Draft changes to clause 95 including  
TxVEC – rev3  
(post June 12<sup>th</sup> ad hoc review)

MMF ad hoc working document  
Jonathan King

**Figure 95–3—TxVEC conformance test block diagram**

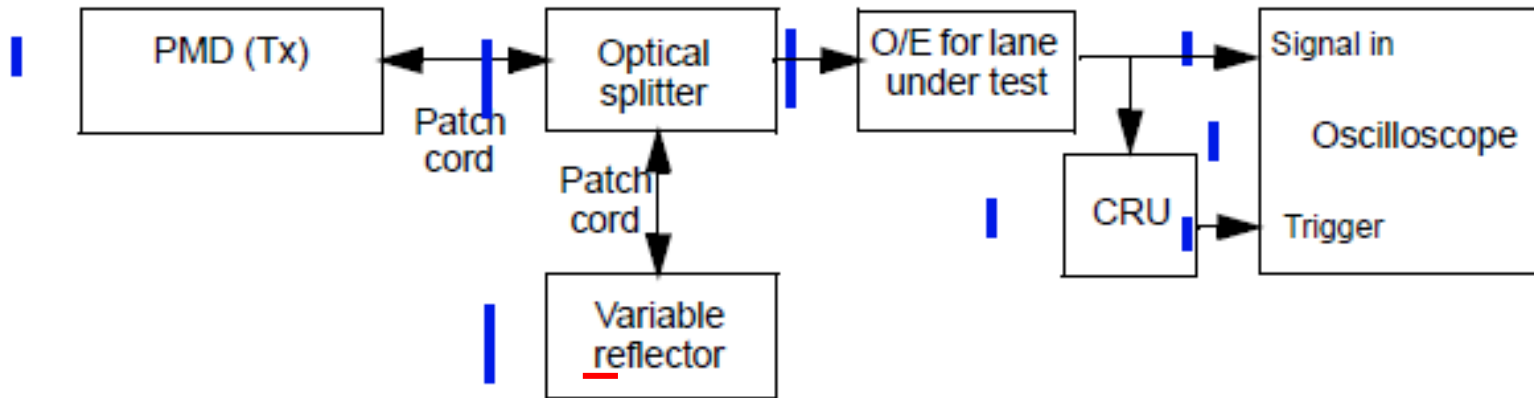
## 95.8.5.1 TxVEC conformance test set-up

A block diagram for the TxVEC conformance test is shown in Figure 95–3. Other measurement

Each optical lane is tested individually with all other lanes in operation. The optical splitter and variable reflector are adjusted so that each transmitter is tested with an optical return loss of 12 dB.

The combination of the O/E and the oscilloscope used to measure the optical waveform has a fourth-order Bessel-Thomson filter response with a bandwidth of 12.6 GHz. Compensation may be made for any deviation from an ideal fourth-order Bessel-Thomson response.

The clock recovery unit (CRU) has a corner frequency of 10 MHz and a slope of 20 dB/decade.

Figure 95-4—Illustration of the TxVEC measurement

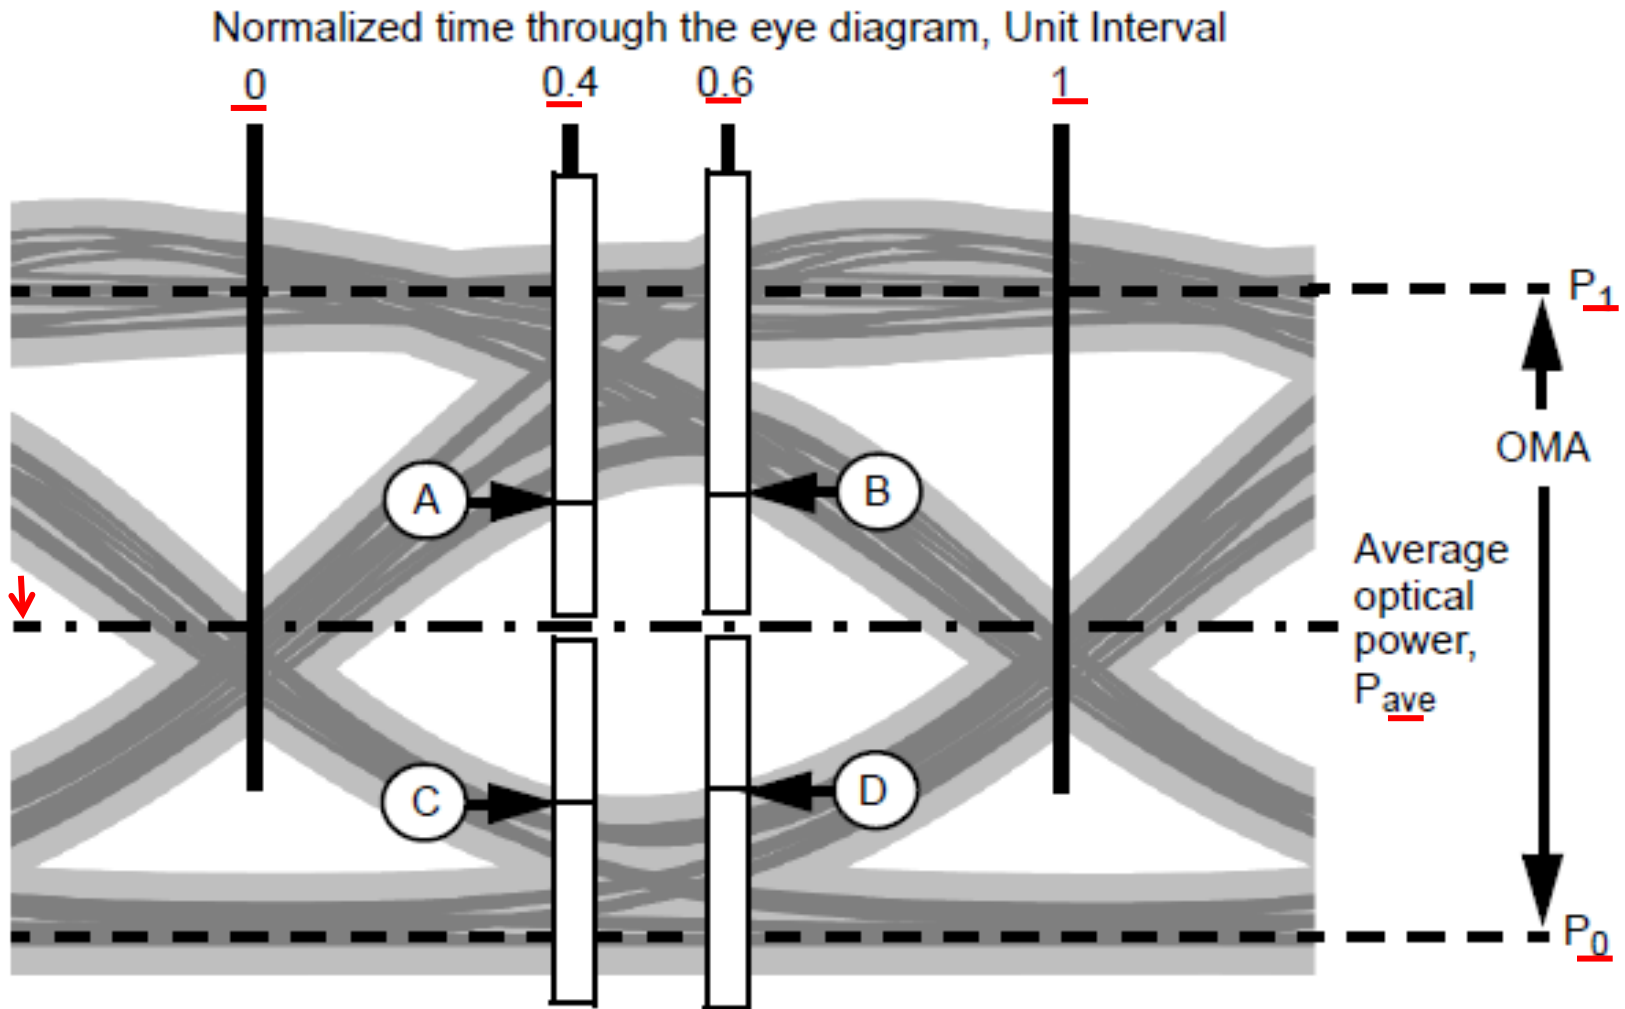
The oscilloscope is set up to accumulate samples of the optical eye diagram for the transmitter under test, as illustrated in Figure 95–4.

The 0 UI and 1 UI crossing points are determined by the time average of the eye diagram crossing points, as measured at  $P_{ave}$ , as illustrated in Figure 95–4.

Four vertical histograms are measured through the eye diagram, centered at 0.4 UI and 0.6 UI, and above and below  $P_{ave}$ , as illustrated in Figure 95–4.

Each histogram window has a width of 0.04 UI. Each histogram window has an inner height boundary which is set close to  $P_{ave}$  (so that no further samples would be captured by moving it closer to  $P_{ave}$ ), and an outer height boundary which is set beyond the outer-most samples of the eye diagram, so that no further samples would be captured by increasing the outer boundary of the histogram. Starting from the boundaries closest to  $P_{ave}$ , the power at which the cumulative distribution of each histogram equals the 0.005th percentile of the total number of samples in the histogram is determined (these are the powers A, B, C, and D, illustrated in Figure 95–4).
